Engineering Assessment Report

Residential Development at Auburn, Malahide Road

Client Name: Kinwest Limited
Document Reference: 19-020r.003 Engineering Assessment Report
Project Number: 19-020

3.1 Problem

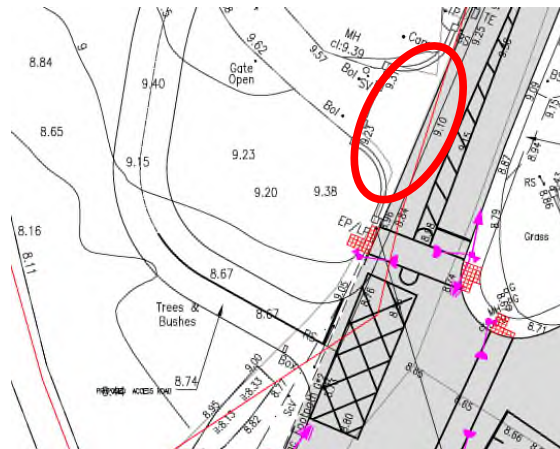
Drawing P120 Rev -

The drawing does not show that the new access arm of the junction is to be signalised or where the signal heads will be located. If this arm of the junction is not signalised drivers may enter the junction at the same time as traffic in another arm moves forward which could result in side-impact or side-swipe collisions.

3.1	Yes	Yes	The existing access is to be closed to vehicles as part of the proposed development. The drawings have been revised to clarify this. The access will remain open to pedestrians only.	Yes

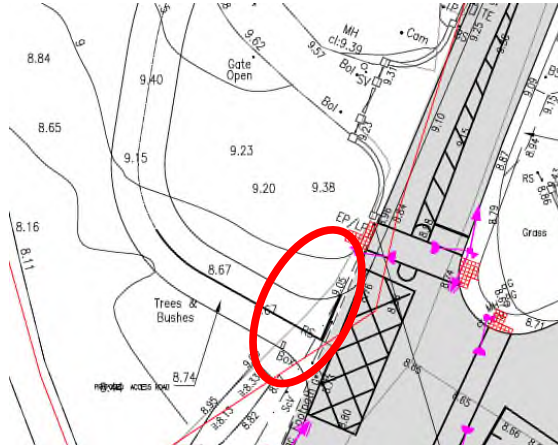
It is recommended that the new access arm of the junction be signalised.

3.2	Yes	Yes	The junction is proposed as a signalized junction. Please refer to drawing <i>19-020-P110 Proposed Malahide Road Junction Upgrade Layout</i> , which shows the proposed junction layout including signal head locations.	Yes

3.3 Problem

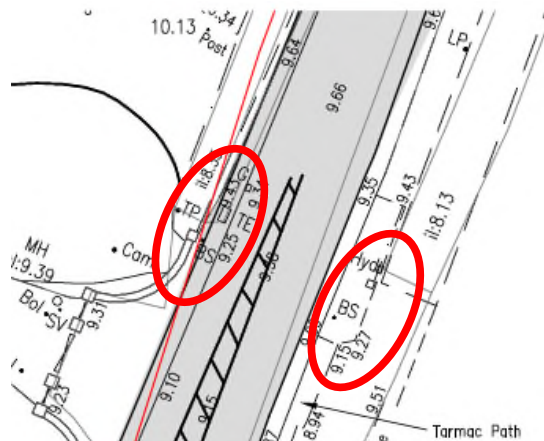
Drawing P120 Rev -

It is recommended that the bus stops and paths to the bus stops from the signalised pedestrian crossing are included in the design.

3.4 Problem

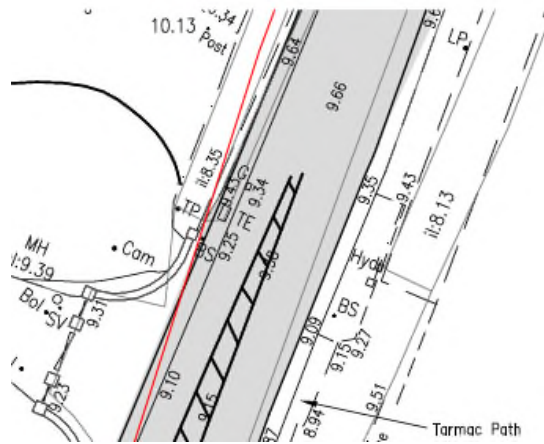
Drawing P120 Rev -

It is recommended that cyclist facilities be included in the junction design.

3.4	Yes	Yes	The proposed R107 Malahide Road / Back Road junction design considers cyclist safety. Advanced stop lines to accommodate cyclists are proposed on the southern, northern and eastern approaches of the junction, with a 15m length of advisory cycle lane provided on the approaches to the junction. These advanced stop lines will provide a safe area for cyclists in front of vehicular queues and help cyclists	Yes

3.5 Problem

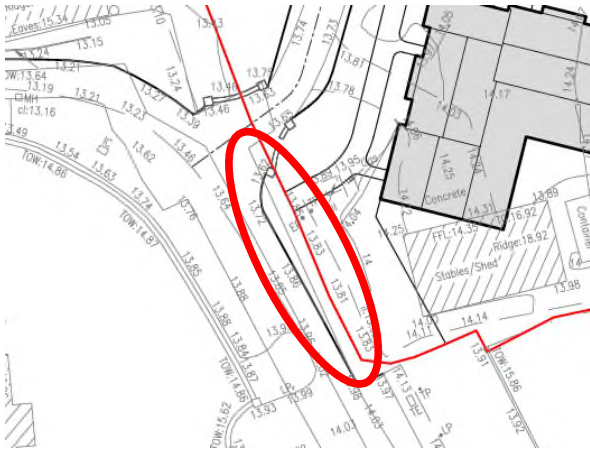
Drawing P102 Rev -

position themselves correctly for right/left turning movements.	
3.5	Yes	Yes	A continuous footpath connection to the existing footpath on Carey's Lane is now provided. Refer to drawing 19-020-P102 Road Layout Sheet 2 of 3.	Yes
